The Principal Registrar  
Planning & Environment List  
Victoria Civil and Administrative Tribunal (VCAT)  
55 King Street  
MELBOURNE VIC 3000

**Re: 1161 BURWOOD HWY UPPER FENTREE GULLY  
PLANNING PERMIT NO. P/2020/6347  
AMENDMENT TO PERMIT UNDER SECTION 87A of the ACT**

The application for amendment to the Permit is made to:

Figure 2: Proposed amended car parking layout as per TP03.1 Revision 8 dated 11 October 2024.

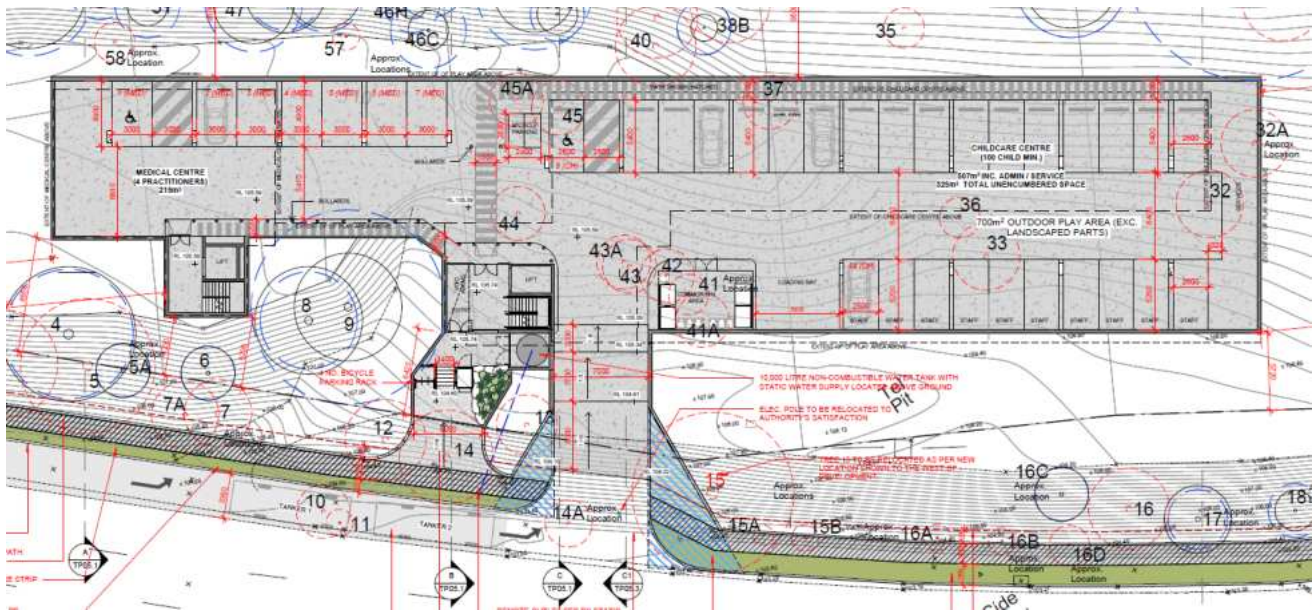
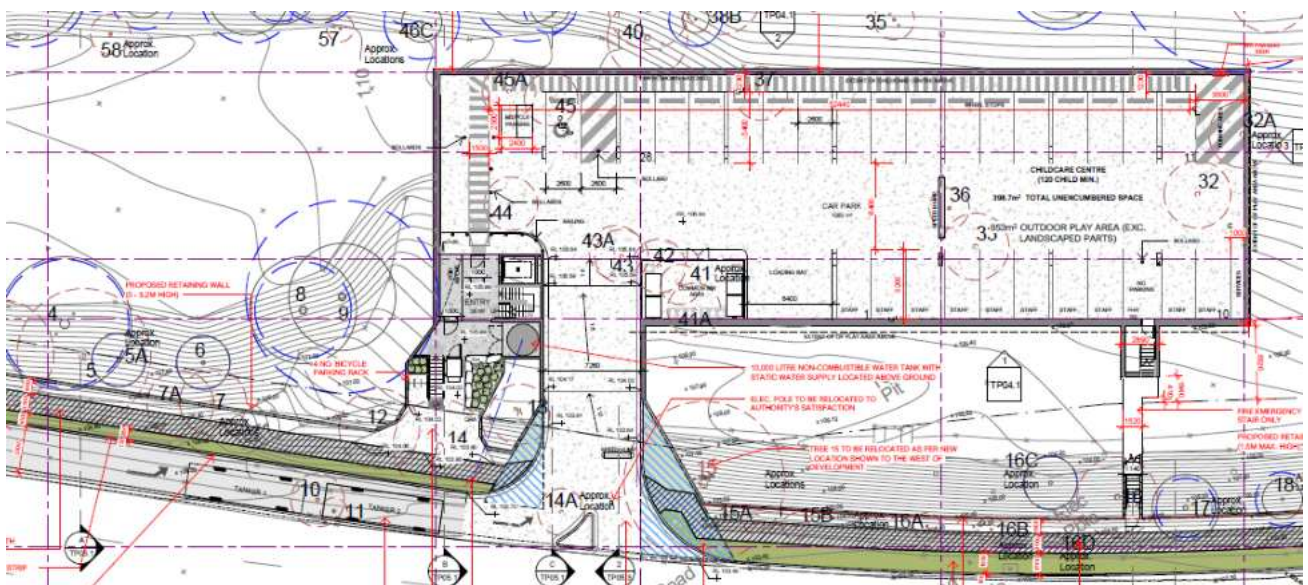
The proposed car parking level as depicted on TP03.1 is to be reduced to remove the car parking spaces associated with the previous medical centre use. The considered VCAT Plans included a total of 34 car parking spaces within the car park level including 27 allocated for the childcare centre and 7 allocated for the medical centre.

The medical centre car parking spaces were allocated within the western side of the car park level with a separate stair and lift provided to the previously proposed medical centre above as per the figure below.

The amended plans under this application remove the medical centre car parking area and the associated 7 car parking spaces, lift and stair and turning around area west of the main entry. The location of the car park entry, stairs and slip lane do not change from the considered VCAT plans.

The set back of the car parking level from the east and north boundary has not changed with a minor reduction in the setback of the car park at the south-eastern corner to the south boundary from 5.72m to 5.52m. This level is situated below natural ground level and will not be visible from Burwood Highway.

- Internal reconfiguration of the car parking area to accommodate access to a new fire escape stair in the south-eastern corner (between car parking spaces 8 and 9), increase in the width of the internal loading bay from 6.22m to 6.4m and allowance for a turn around area at the north-eastern corner.

- The finished floor level of the car park has increased from RL105.59 to RL 105.84 (0.25m increase) to facilitate the ramp grades and vehicle and pedestrian entrance from Burwood Highway.

- The entrance ramp width has increased from 7.0m to 7.26m to improve vehicular access.

Figure 4: Proposed childcare level as per TP03.2 Revision 8 dated 11 October 2024 (outline of previous building highlighted in blue dotted line)

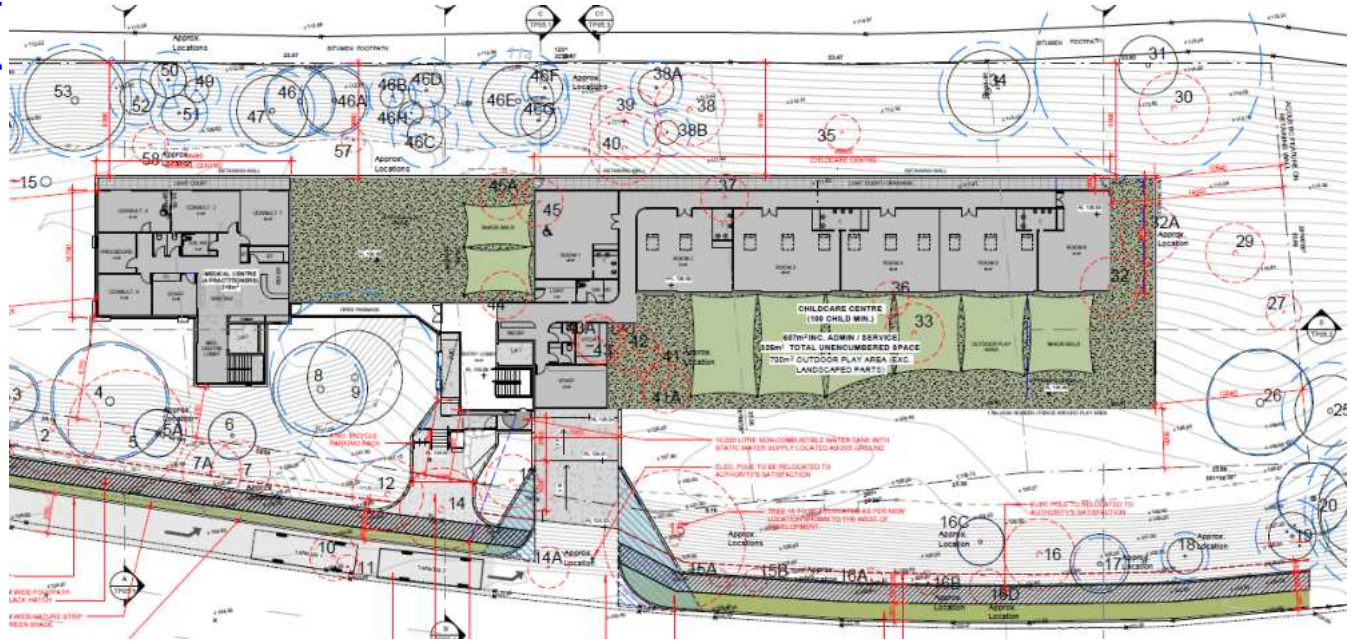
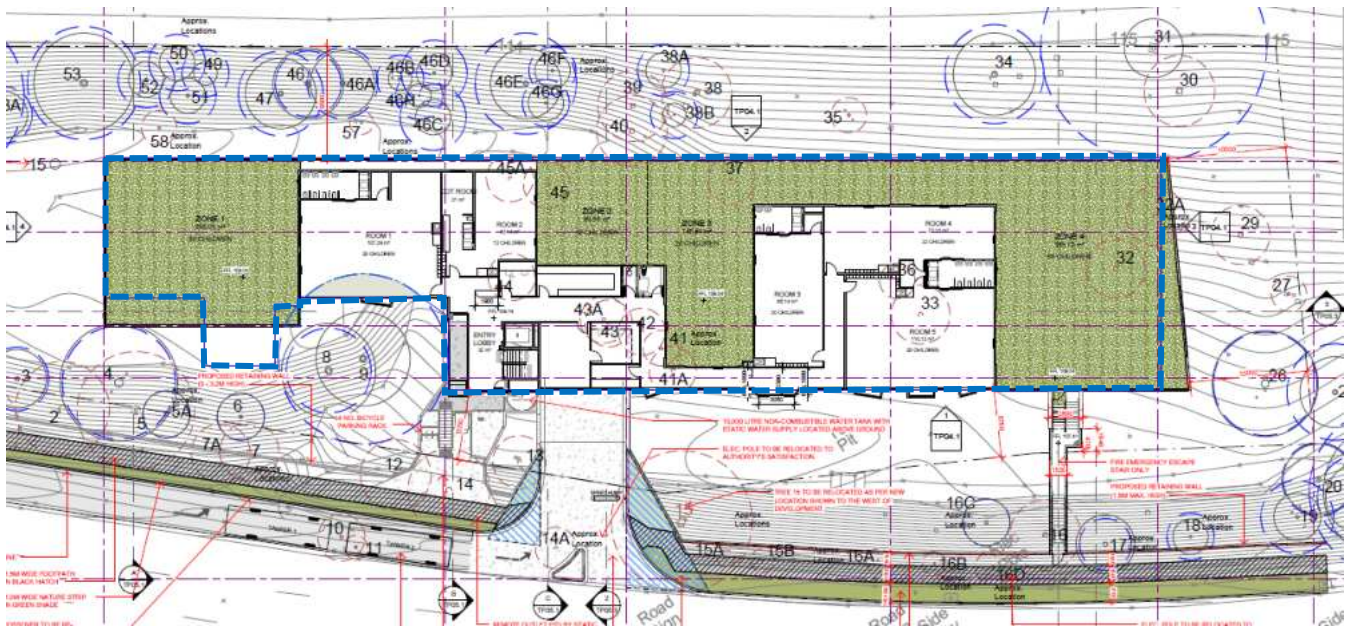
The proposed childcare level is to be amended primarily to remove the previous 215sqm medical centre at the western end of the building with this area to be replaced with an outdoor play area associated with the childcare centre. Changes are also being made to the childcare centre layout of rooms and play areas. The changes to the layout reflect the specific requirements of the tenant for the childcare centre.

The VCAT considered plans included the childcare centre building setback towards the northern section of the building footprint with outdoor play areas located on the southern side and to the west. The medical centre included a built form at the western edge of the building with a stair case and entry siting forward of the main building.

- Reducing the number of rooms from 6 to 5 and splitting the outdoor play area into four zones.
- The entry lobby and office administration areas reconfigured and moved to the southern boundary line with Rooms 1 and 2 moved to the rear of the entrance area.

- Splitting the childcare centre building into two building modules with a connecting corridor with the eastern most building element containing 3 childcare rooms and the building moved to the southern building footprint. Outdoor play area provided to the east, north and west of Rooms 3, 4 and 5.

- A revised outdoor play area (Zone 4) is proposed at the western end of the building in place of the previous medical centre building element.
- The finished floor level of this level has increased from RL 108.89 to RL 109.04 (0.15m increase).

- The setback of the building footprint to the Burwood Highway east of the entry has not changed with a small reduction in the setback of outdoor play area Zone 4 to the east boundary from 10.64m-12.54m to 10m.

- The setback of the building footprint from Burwood Highway west of the entry has increased with the removal of the medical centre stair well and lift.
